Sydney Modern Project
State Significant Development
DA SSD 6471 3/11/17

Development Application and Environmental Impact Statement

Grounds of Objection

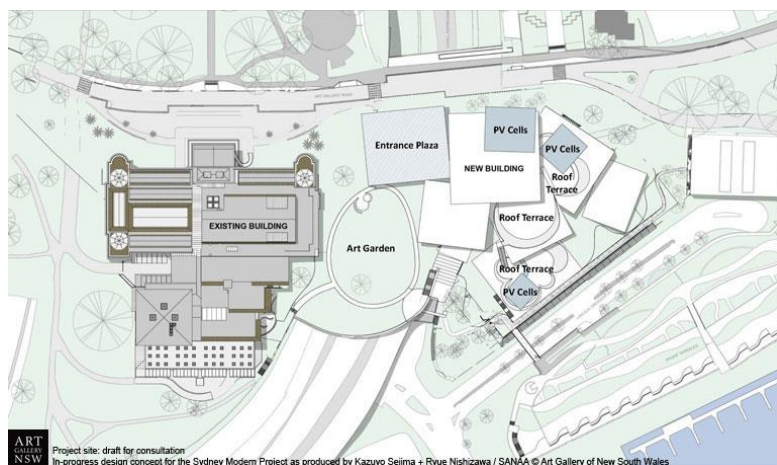
The overriding objection to the location and design of this proposal, and the fundamental reason why it should not be approved, is because of its negative impact on and inconsistency with the heritage, natural and public open space values of:-

- the Domain,
- the surrounds of the grand and historic AGNSW gallery and
- the entrances to the Royal Botanic Garden and Mrs Macquarie's Point, with their defining stands of trees and public views over the adjacent Domain lands to the Harbour beyond.

This loss of public amenity is unnecessary as the cultural objectives can be equally if not better achieved in other places and in different ways without building on this location.

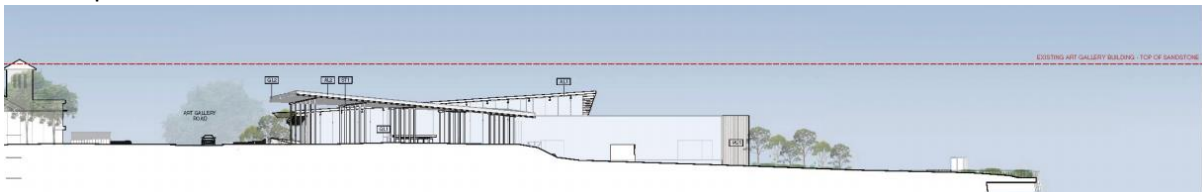
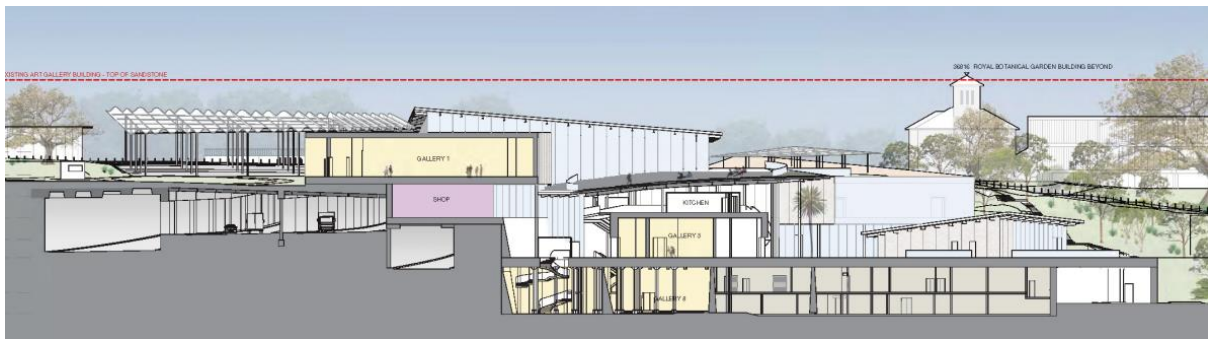
3. change the visual relationship between the Garden and Domain and the historic buildings group along Macquarie Street, Hospital Road and St. Mary's Cathedral with the insertion of an ultra-modern architectural style. These buildings are part of the setting of the Garden and Domain, and the Garden and Domain in turn form a parkland backdrop setting for these buildings, which is appreciated by their users and the public.

They will change from this.....

....to this

- **South East, new building below existing Gallery**

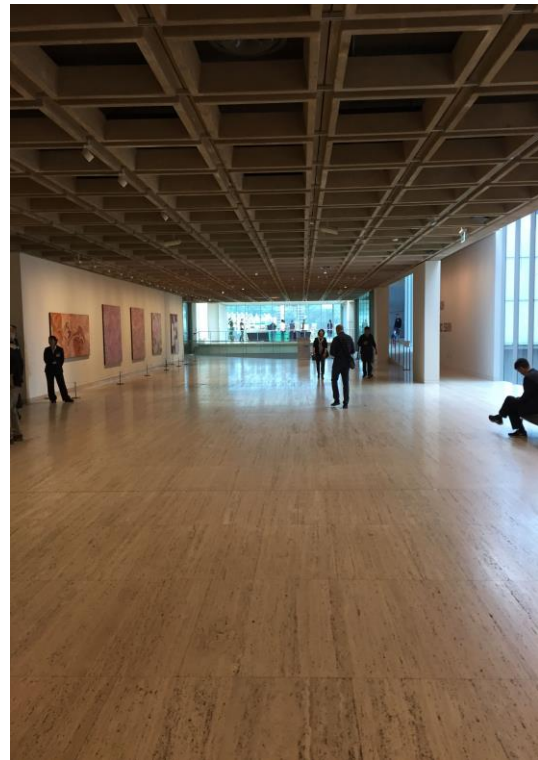
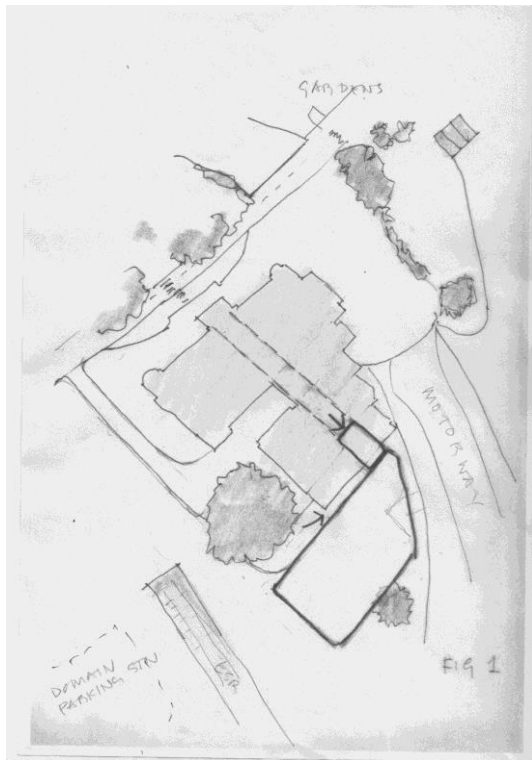
If the Government is intent on co-locating Sydney Modern in the Domain, the most suitable site would be to the **south east** of the Gallery building, between that building, the Eastern Distributor and the railway. A landscape evaluation of the whole Domain would probably identify this area as having the lowest, or near lowest, aesthetic or use value of any of the area's parts. This façade of the gallery has already been compromised by various additions.

The statement (p.25 EIS) that a building in this location would impact on the view of the Vernon façade and the Police Memorial is factually incorrect (see graphic). In fact a south east site would offer the least landscape and heritage impact. David Chesterman has identified that there is potential for a four-storey building with superior vistas without compromising the existing gallery. Such a building could seamlessly link with the existing building. The entrances to each building would have a strong visible link to one another, sharing an arrival point. This would overcome concerns about cohesiveness and the detriment to the Garden entrance, and would create a coherent 'civic precinct'.

A four-storey building on this site would provide Sydney Modern with **plenty of space**, would be **convenient, prominent**, would offer very **good outward views** (including the Harbour), and could be **easily serviced** using existing roads.

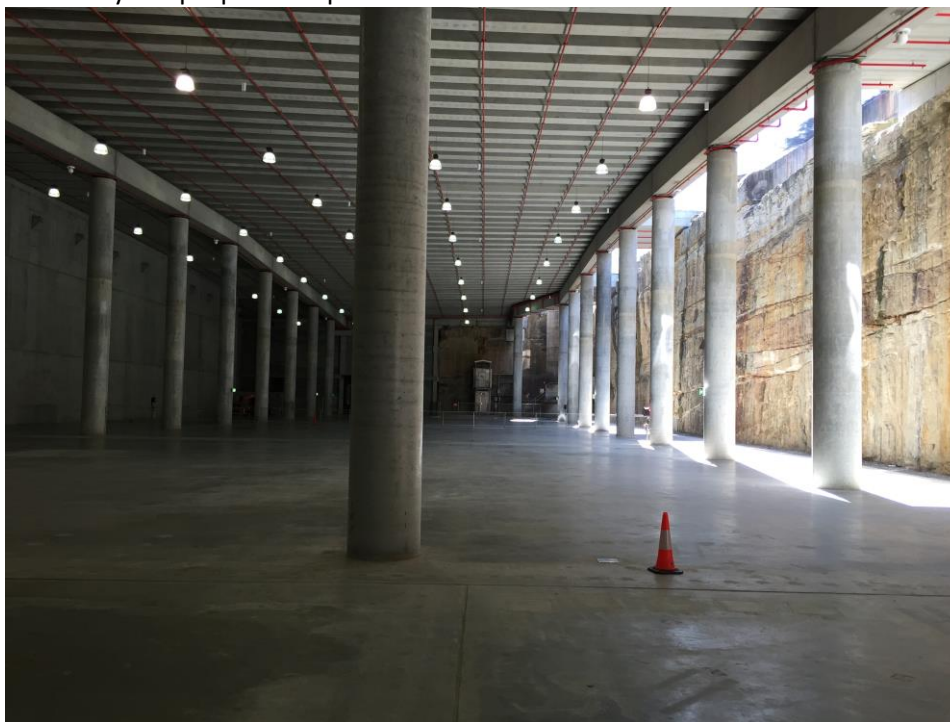
It is noteworthy that on the Eastern Suburbs railway line there is a void right on that South East corner for a railway station to serve the Gallery.
